# USB 3.1 ENGINEERING CHANGE NOTICE FORM

**Title: USB3.1 SCD Clarifications**

**Applied to: USB3.1**

**From Figure 6-33.**

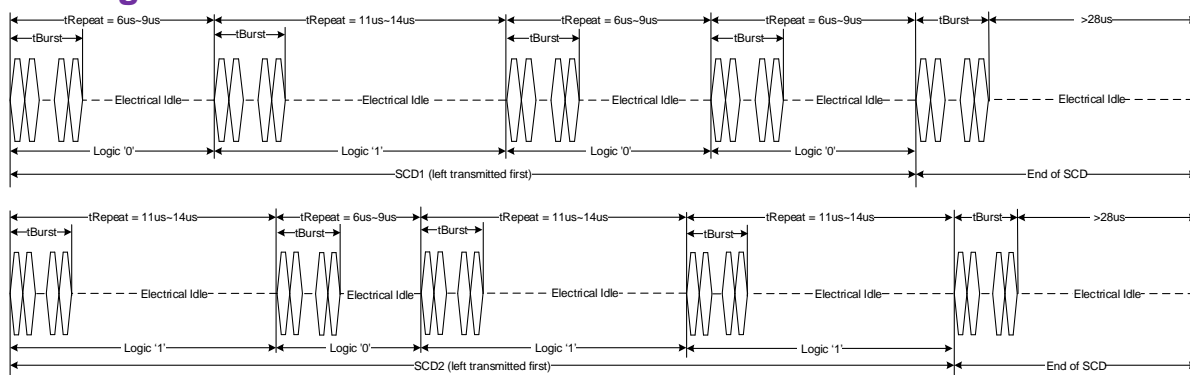
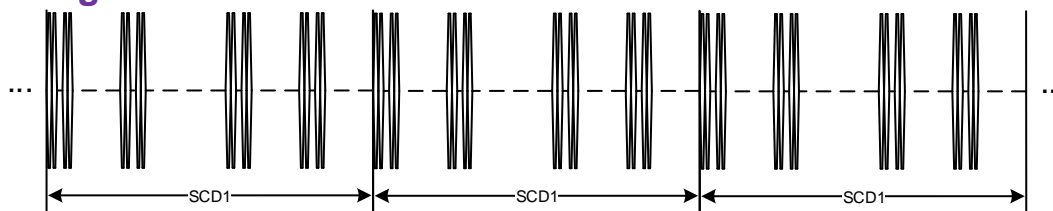
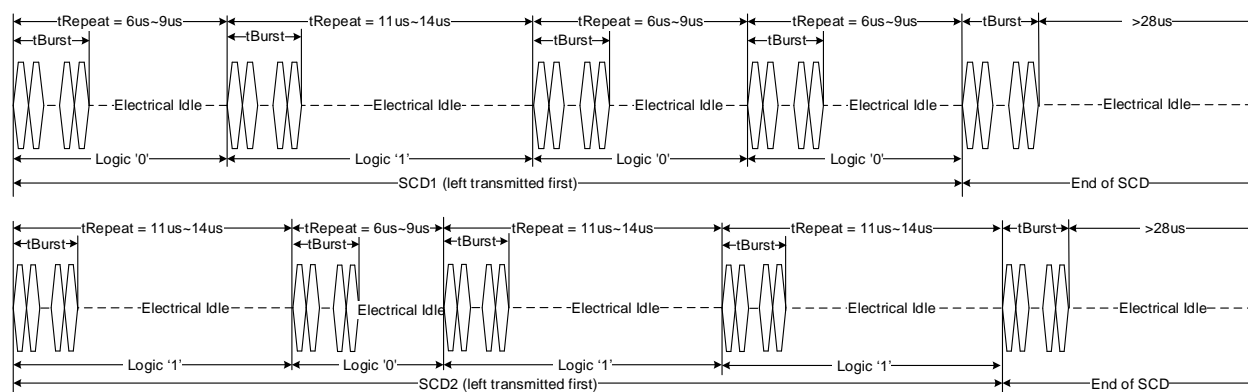
Clarifications on how back to back or consecutive SCD1/SCD2 shall be transmitted.  
Background: the transmission of SCD1/SCD2 in Polling.LFPS must meet the SS requirement to present as continuous Polling.LFPS. This means an SSP port in Polling.LFPS must transmit SCD1/SCD2 consecutively. In other words, consecutive (or back to back) SCD1s must be transmitted as SCD1-SCD1-...SCD1 without end of SCD in between SCD1s.  
The potential confusion in the spec arises in Section 6.9.4, where Figure 6-33 only illustrates an example of SCD1/SCD2 transmission with one SCD1 followed by end of SCD. The lack of examples for back to back SCD1/SCD2 transmission results in some implementation interpreting SCD1/SCD2 transmission in Polling.LFPS/Polling.LFPSPlus as "SCD1-end of SCD-SCD1-end of SCD1-...". This is a violation to the SS operation because of the non-continuous Polling.LFPS transmission.

1. Add examples in Figure 6-33 back to back SCD1 or SCD2 transmission
2. Add examples in Figure 6-33 back to back SCD1 and SCD2 transmission when transitioning from Polling.LFPS to Polling.LFPSPlus

- The transmission shall be LSb first, and consecutive SCD1/SCD2 shall be transmitted back to back. Shown in Figure 6-33(a) is an example of consecutive SCD1 transmission.
- The transmission shall be completed with an extra tBurst followed by electrical idle (EI) of at least 2x the maximum allowable tRepeat value as shown in Figure 6-33(b).

(a). Illustration of back to back (consecutive) SCD1 transmission

(b). Illustrations of end of SCD1 or SCD2 transmission
